Access Audit Site Report

Bonham State Park
1363 State Park 24
Bonham, TX 75418
Accessibility Evaluation
Inspection Date: 10/15/2021
Inspectors: Tanya Scheibe

**TEXAS PARKS AND WILDLIFE DEPARTMENT
BONHAM STATE PARK**

**AMERICANS WITH DISABILITIES ACT COMPLIANCE INITIATIVE
PROGRAM AND POLICY REPORT
JULY 28, 2023**

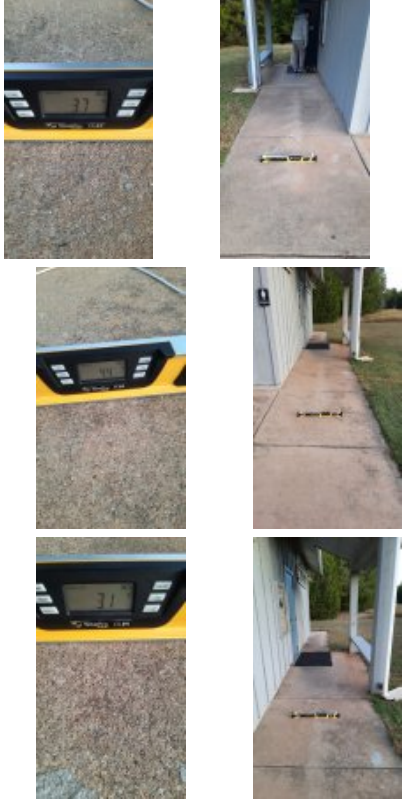
Finding Number	Area Description	Lat/Long	Finding	As Built	Recommendation	Citation	Photos	Figure
1	Headquarters Area: HQ Parking	[33.5473544 , -96.144796 5]	The cross slopes (narrow dimension) and/or running slopes (long dimension) of the access aisle exceeds 2%. The running slope and the cross slope in an accessible parking stall and the access aisle must not exceed 2%.	5.2% slope in stall, 4% slope in aisle	Repair or correct slope of parking space and access aisle to max 2.08% in any direction	2015 ABAAS Section: 502.4 2012 TAS Section: 502.4 2010 ADAS Section: 502.4		
2	Headquarters Area: HQ Parking	[33.5473835 , -96.144772 4]	The van stall is missing a sign identifying it as a van accessible stall. Parking space identification signs shall include the International Symbol of Accessibility. Signs identifying van parking spaces shall contain the designation "van accessible."	Lacks van sign	Add one van parking sign to van accessible stall and ensure stall and access aisle are 11' and 5' or 8' and 8'	2015 ABAAS Section: 502.6 2012 TAS Section: 502.6 2010 ADAS Section: 502.6

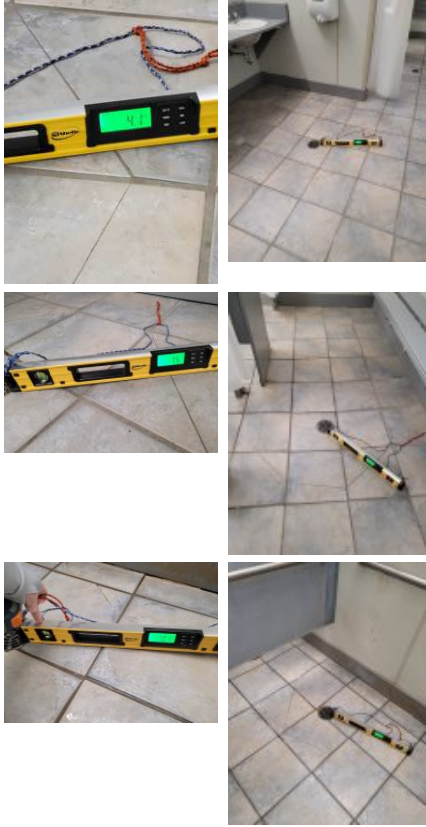
20	Headquarters Area: HQ Men's Restroom	[33.5474517, -96.144889 2]	Alternate roll-in type shower compartments shall be 36 inches (915 mm) wide and 60 inches (1525 mm) deep minimum clear inside dimensions measured at center points of opposing sides. A 36 inch (915 mm) wide minimum entry shall be provided at one end of the long side of the compartment.	Lacks 36" wide opening, 35" wide	Enlarge shower stall entry, if feasible, to compliant dimensions of 36" opening on the long dimension	2015 ABAAS Section: 608.2.3 2012 TAS Section: 608.2.3 2010 ADAS Section: 608.2.3

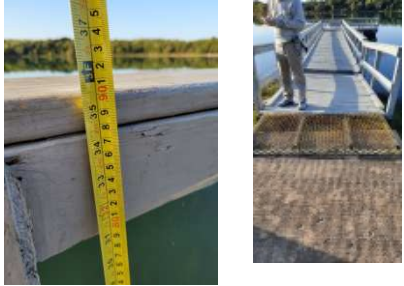
47	Headquarters Area: HQ Women's Restroom	[33.5474684, -96.1449065]	The toilet seat is not located within the range allowed off the floor. The height of accessible water closets shall be a minimum of 17 inches and a maximum of 19 inches measured to the top of a maximum 2-inch high toilet seat.	Seat height 19.5"	Replace toilet seat, or re-set or replace toilet to 17" to 19" aff	2015 ABAAS Section: 604.4 2012 TAS Section: 604.4 2010 ADAS Section: 604.4

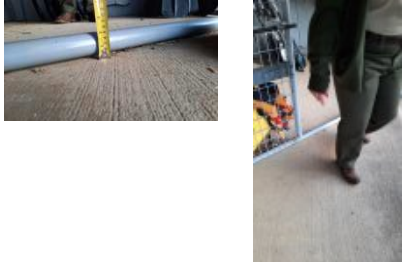
51	Headquarters Area: HQ Women's Restroom	[33.547464, -96.144877]	The dryer projects more than 4 inches into the circulation path. Wall-mounted objects that have leading edges between 27 inches and 80 inches from the floor must not project more than 4 inches into the circulation path. Protruding objects that extend to the floor or within 27 inches of the floor are cane detectable and are therefore not hazardous. Where it is necessary or desirable to have objects protrude from the wall, a manner of cane detection must be provided.	Hand dryer protrudes	Relocate protruding objects or place cane detectable warning or bollard at foot of item.	2015 ABAAS Section: 307.2 2012 TAS Section: 307.2 2010 ADAS Section: 307.2		
52	Headquarters Area: HQ Women's Restroom	[33.5474707, -96.1448877]	The accessible route contains running slopes greater than 5 percent and cross slopes greater than 2 percent across the width of the walk and has not been constructed as a ramp (i.e. handrails, wheel guides, etc.). When the slope in the direction of travel of any walk exceeds 1 unit vertical in 20 units horizontal (5-percent slope), it must be constructed as ramp. Surface cross slopes must not exceed one unit vertical in 48 units. Horizontal	8.4% slope at drain	Correct or repair slope to max 2.08% cross.	2015 ABAAS Section: 403.3 2012 TAS Section: 403.3 2010 ADAS Section: 403.3

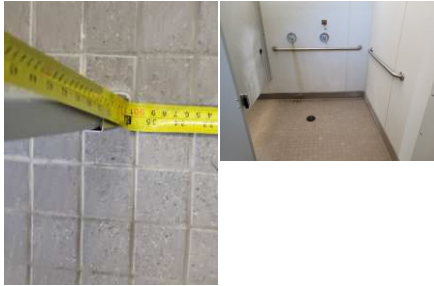
121	Group Barracks: Group Barracks	[33.5465843 , -96.140629 7]	The rear grab bar is not 36" long or is not mounted in the correct location. The rear grab bar must be a minimum of 36" long and extend from the toilet centerline a minimum 12" towards the wall side and a minimum 24" towards the open side of the toilet. Grab bars shall be installed in a horizontal position, 33 inches minimum and 36 inches maximum above the finish floor measured to the top of the gripping surface and the space between the grab bar and the top of the tank shall be 1-1/2 inches minimum.	Staff restroom - 24" bar, not centered	Replace rear grab bar with one 36" long, mounted behind the toilet, 12" to one side of center and 24" to the other and 33" to 36" above finish floor (AFF)	2015 ABAAS Section: 604.5.2 2012 TAS Section: 604.5.2 2010 ADAS Section: 604.5.2
